Auto switching keymap hardware patch #1 for OneChipBook/MSXBOOK.

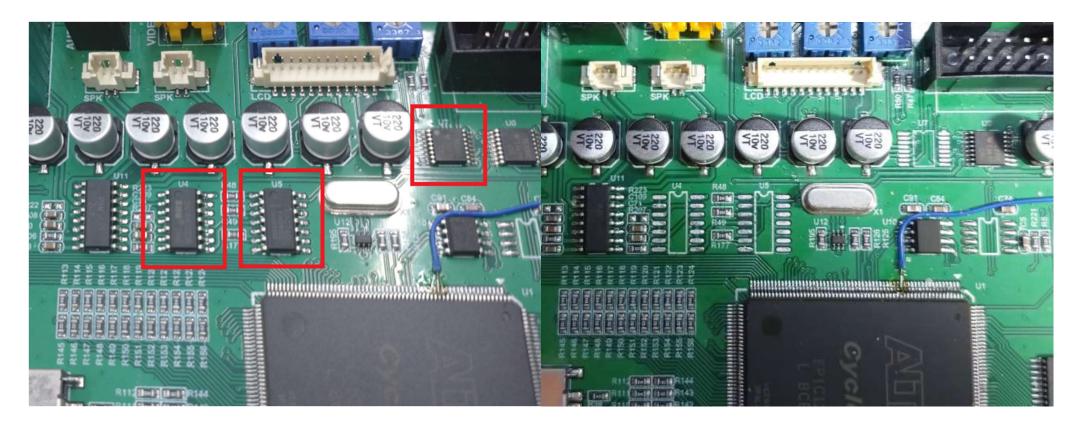
From pin #28 of connector "CON15" on Main Board PCB to pin #17 on Cyclone.
